CERTIFICATE OF APPROPRIATENESS PLACARD

Install mechanical equipment; alter rear window

220 N East St

COA-0116-2020

Figure 2. Close up of Window to be replaced.

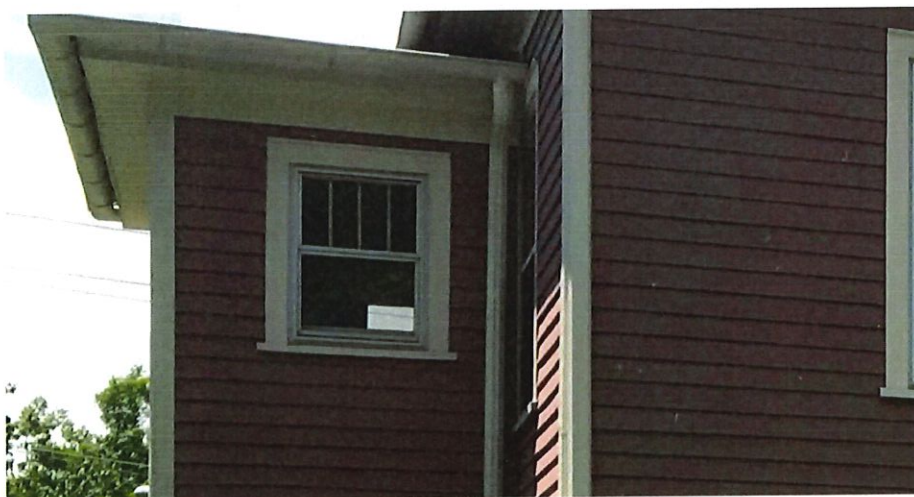
Due to the location of the window on the house, having no muntins in the proposed window is acceptable. Unless you tell us differently, we will assume that the new window will have flat casing trim like everything else on the house.

The window specifications note that the proposed window product is a clad wood window. Staff is not able to approve clad window installation on the historic house at the minor work level. There are a couple of ways to move forward. If you are interested in switching to an all-wood window, staff can review the request as a minor work. Alternatively, we are able to convert that part of the application to a separate major work for the RHDC's COA Committee to review. Clad

The new custom window is an all wood JELD-WEN CWA3020 and have uploaded JELD-WEN specifications to the portal (file "Wood_Awn_SizingChart_13Aug2020.pdf" uploaded to portal). It has frame size 30"x20", e.g., head and sill jamb equal to 30" and side jamb equal to 20", and is configured for a rough opening of 30 ¾" x20 ¾". This matches the existing window head jamb in width, e.g., 30" and is approximately ½ of the existing window side jamb height. The width of head, side and sill jambs equals 5 ¼" which matches the existing window. I would agree to a horizontal muntin profile that would divide the window into 4 panes if required by the COA, else a single pane is preferred. Please note that the new smaller window will afford the necessary privacy and remove the window from direct line of water from the existing shower.

Figure 4. JELD WEN W-2500 WOOD – Transom Window.

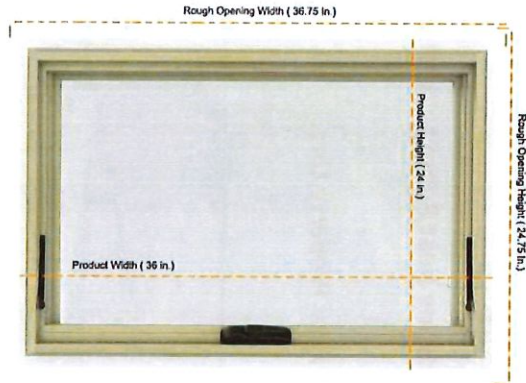
Please provide a photo of the front of the house from the street, as well as a photo of the 1st floor window to be matched. The window specification information you have provided is very helpful, thank you! Please also provide a window section drawing detail, including sill, jamb, and header, and the proposed muntin profile. JELD-WEN will be able to provide this document to you.

3. I selected a new all wood window. I'm not interested in a major work COA.

TRANE XR

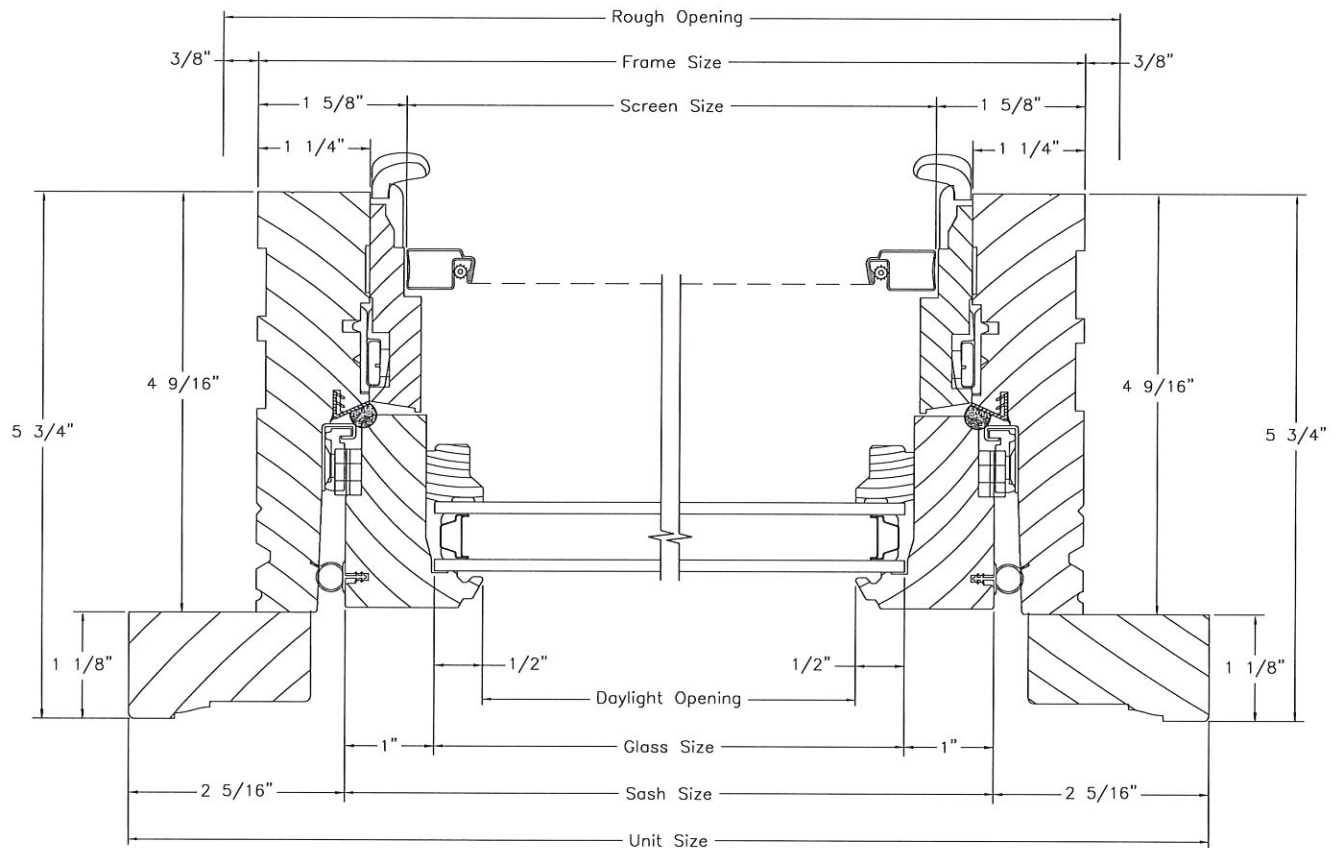
For the mechanical unit, what will the final dimensions of the equipment be, including height? How far from the adjacent house walls will the equipment be installed? Please also provide a photograph of the exact model to be installed. The site plan provided shows an evergreen shrub will be located in front of the proposed mechanical equipment and in the front yard. Are they existing plantings or is the screen planting part of the proposed work? If it is not existing, please provide additional information including proposed species, mature height and width, and number of plants. Please let us know if you have any questions. Thank you.

4. The new downstairs mechanical unit will be identical the existing upstairs unit that was installed with COA approval in spring of 2018. It is a Trane XR model 4twr6030h1000ab. It measures 37" high and 34" wide. The new unit will sit approximately 25ft from our neighbors house. Interestingly, our home sits on a hill and there is a ~ 14ft wall that separates the two properties. The units are not visible from the street. There is however an existing shrub during the last COA approval process in spring of 2018.
